**8-K-20-HZ**  
**APPLICATION FOR CERTIFICATE OF APPROPRIATENESS**

**215 W. Glenwood Ave. 37917**  
**Old North Knoxville H-1**

# Staff Report - Certificate of Appropriateness Application

File Number: 8-K-20-HZ

## NORTH ELEVATION (ALLEY)

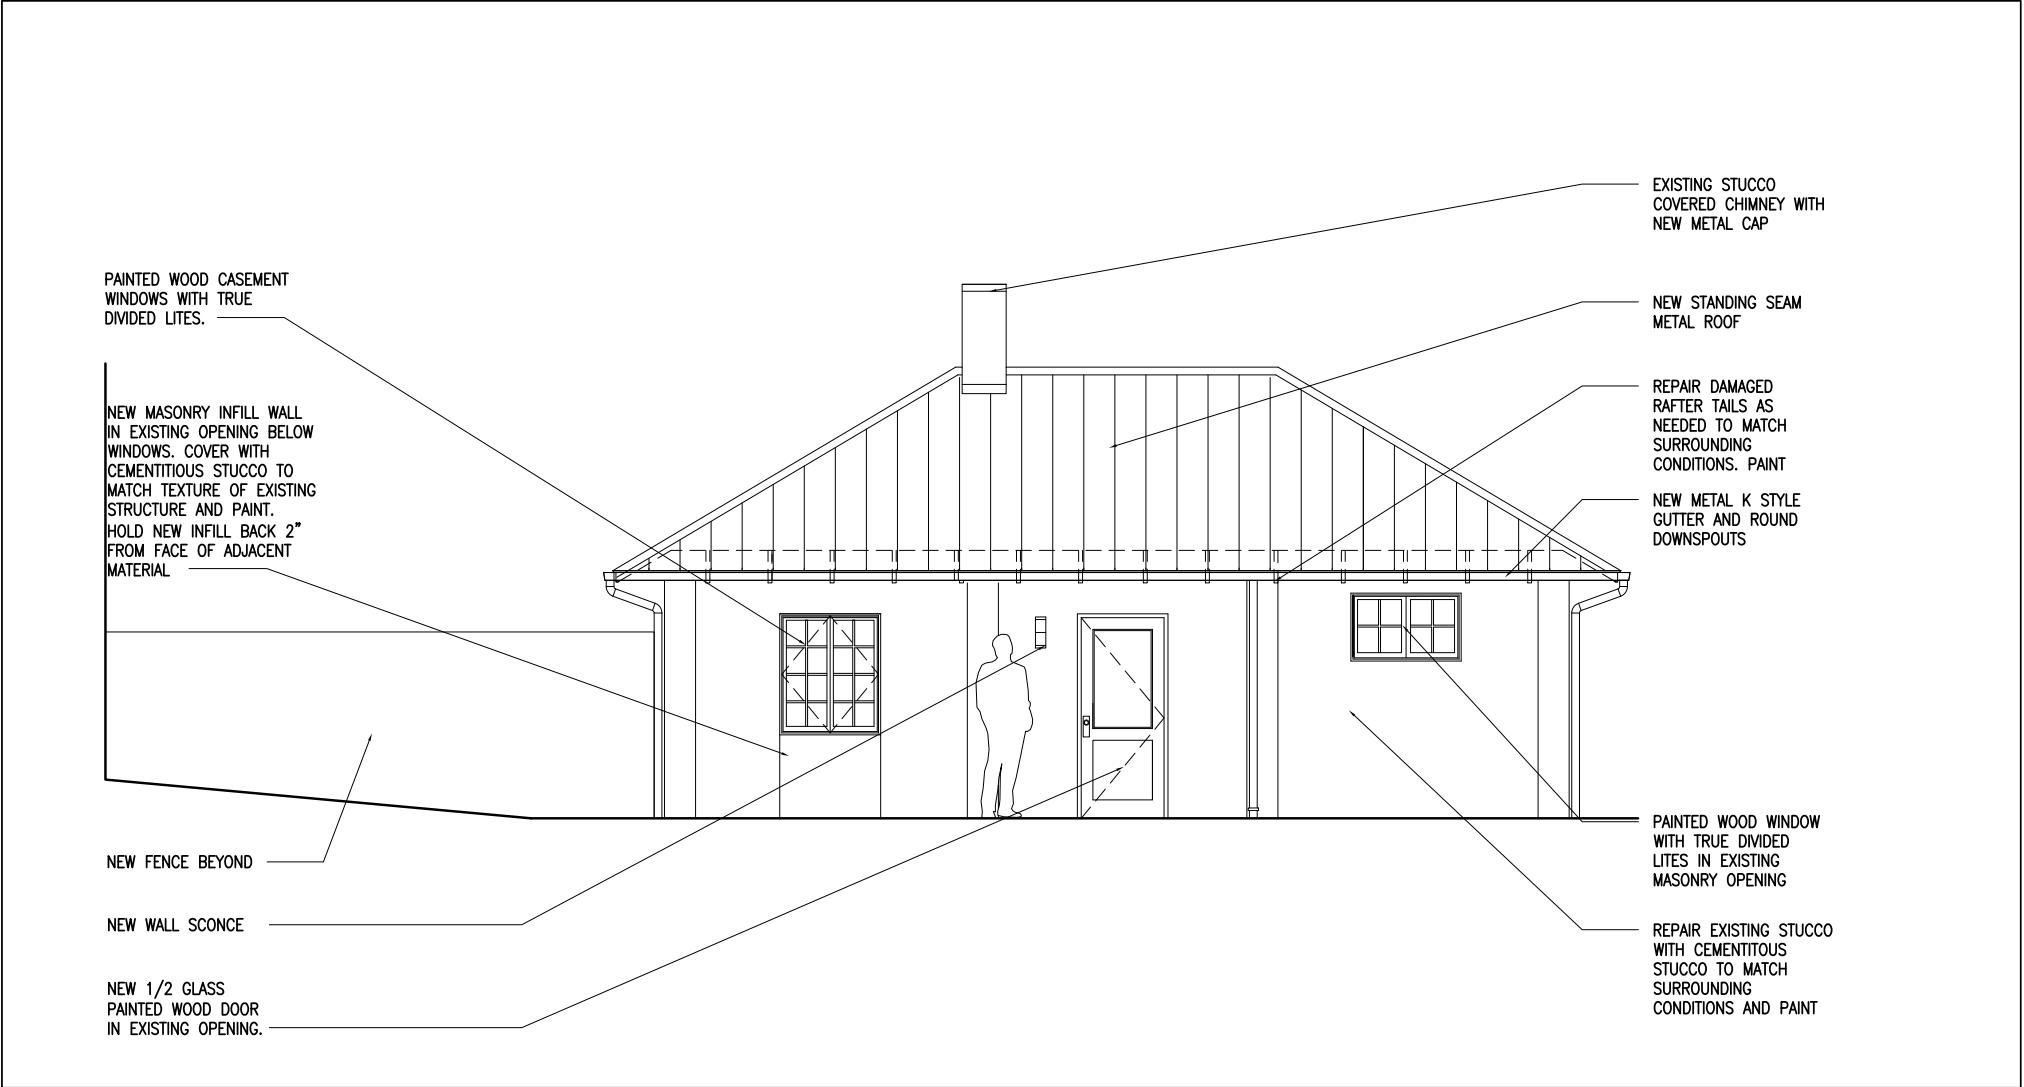
- North (alley) elevation to receive a new shed-roof dormer centrally located on the north roof slope. The dormer will receive painted four-light wood windows and rafter tails to match existing. Existing non-historic garage doors will be removed and openings will receive four sets of three-light wood casement windows with patterned glass. new masonry infill, clad in stucco to match existing exterior materials. Masonry infill to be set back 2" from face of adjacent exterior wall. Repair to existing stucco. Additional set of wood windows on right side.

3. The rehabilitation of the carriage house maintains the appearance of the structure's original use, including the inset masonry infill of the garage doors on the north elevation alley.

4. The materials proposed for the carriage house, including a standing seam metal roof, wood windows, overhanging eaves, and exposed rafter tails, are appropriate within the design guidelines. The dormer addition is modest in size and its roof profile and materials will complement both the carriage house and the proposed rear addition. No historic material is being removed or altered for the rehabilitation of the carriage house.

WEST ELEVATION

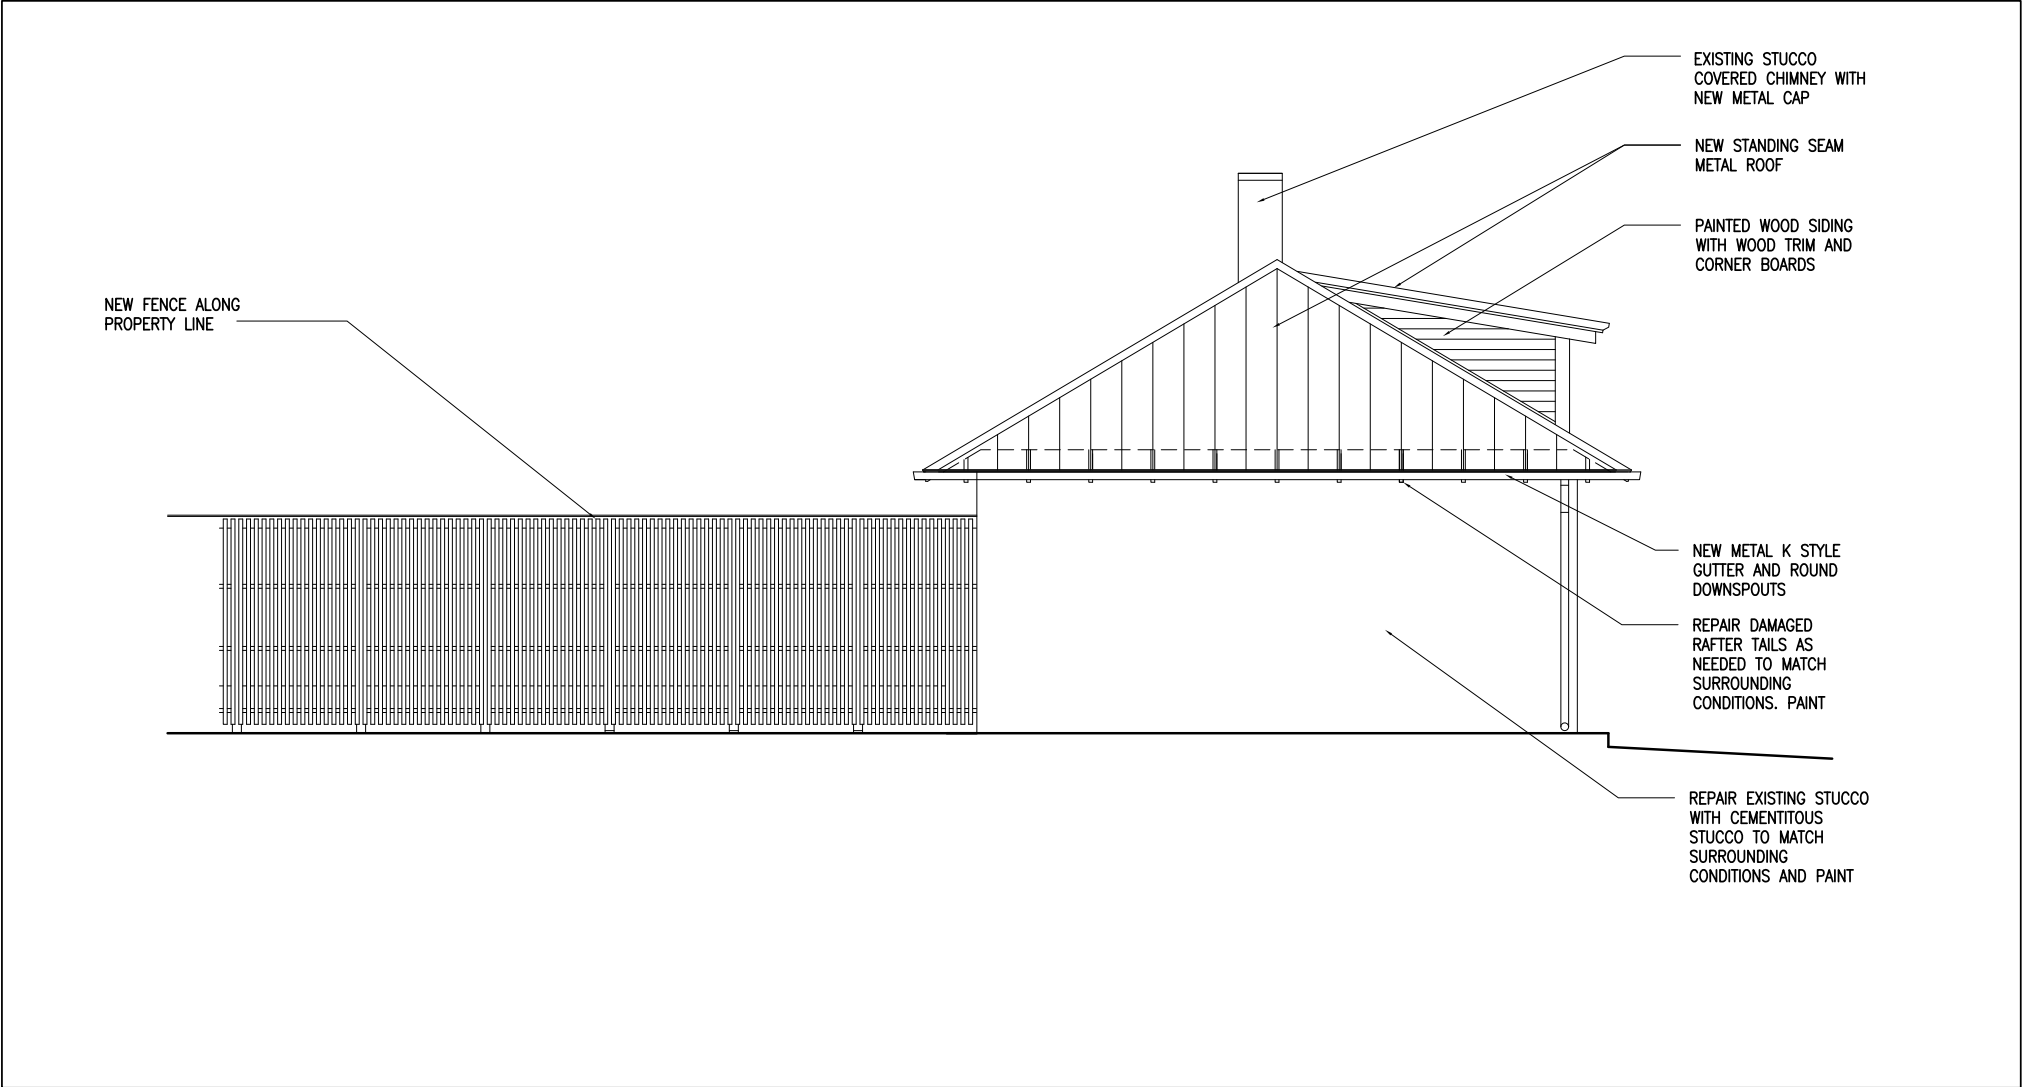
- West elevation to receive paired wood windows.

## NORTH ELEVATION

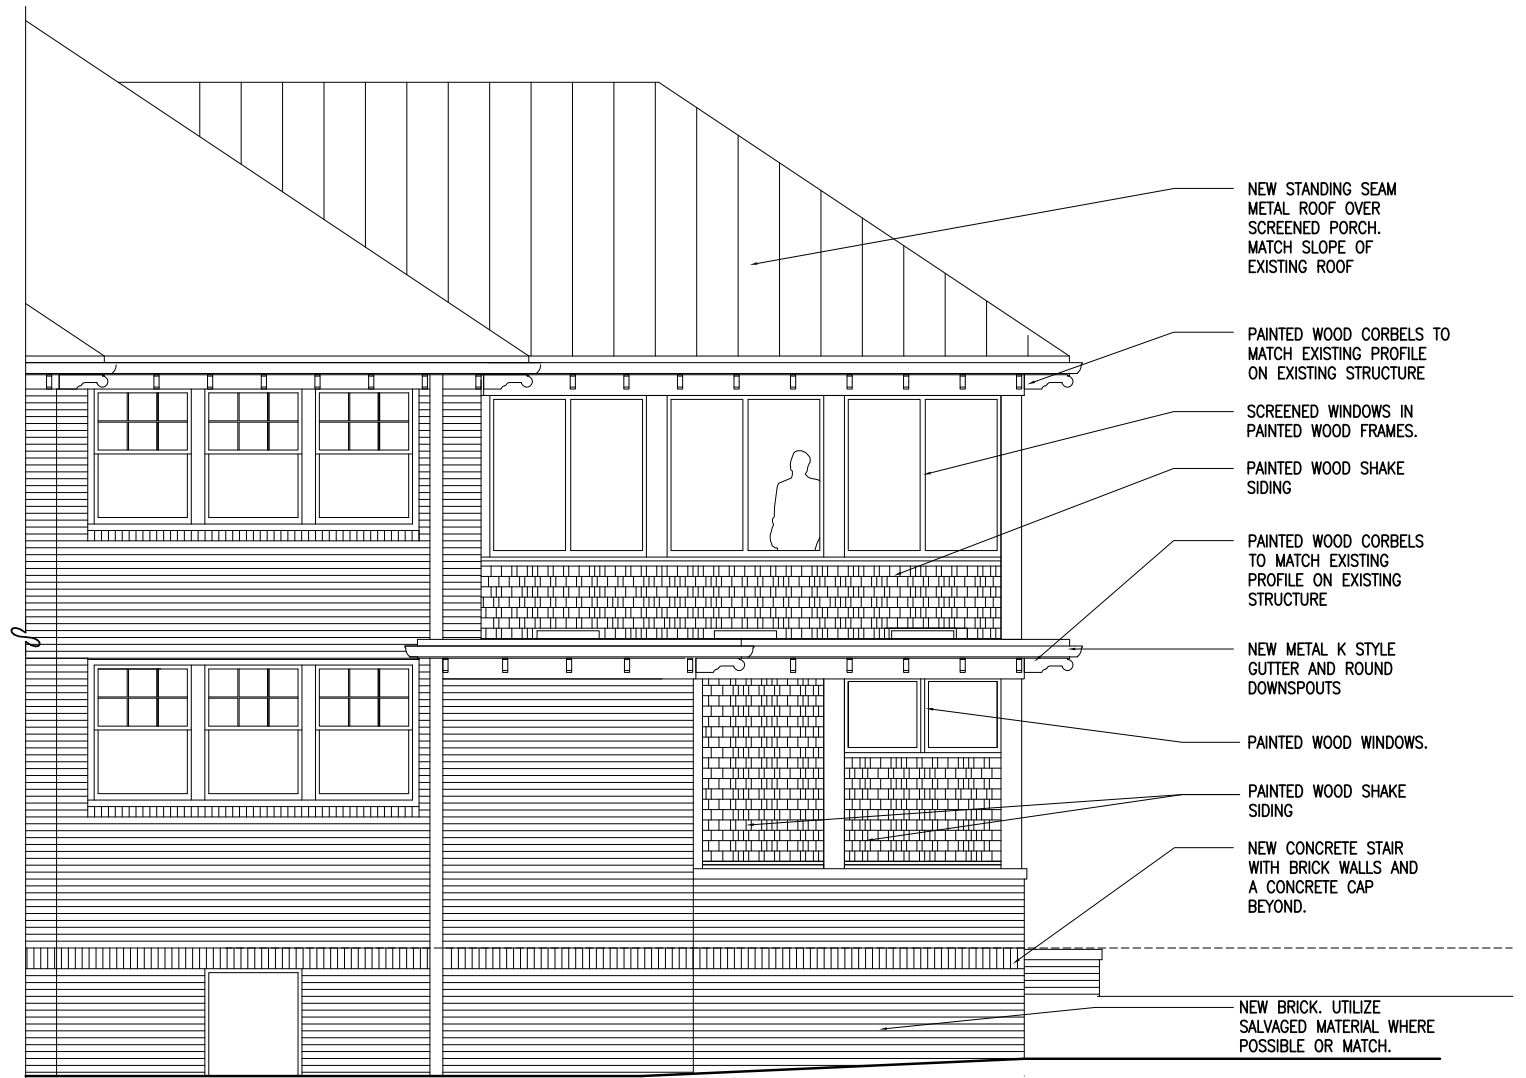
- North elevation: Second story to feature screened windows in wood frames above painted wood shake siding, and first story will have painted single-light wood windows above brick siding and a brick foundation.
- West elevation: Window and siding patterns continue from north elevation; first story will feature a centrally-located single light wood door.
- East elevation: Window and siding patterns to continue from north elevation, with additional painted wood shake siding on first story.

5. The proposed addition is located at the house's rear, in a location not visible from the public right-of-way. The existing rear elevation features a non-historic enclosed sunporch and a second-story door. Placement of the addition is appropriate, and no character-defining features will be altered or removed for the addition. The overall mass of the addition is compatible with the historic house.

6. The addition features a hipped roof that is set lower than the existing roofline, with a pitch that reflects the existing house. Standing-seam metal roofing is an appropriate material within the guidelines and will distinguish the addition from the existing house.

7. Materials, such as the brick to match the existing, wood windows, and a wood full-light door are complementary to the existing house. The wood shakes introduce a new material element to the house, but are limited to small sections of the house, appropriate for the house's Craftsman origins, and will not be visible from the street.
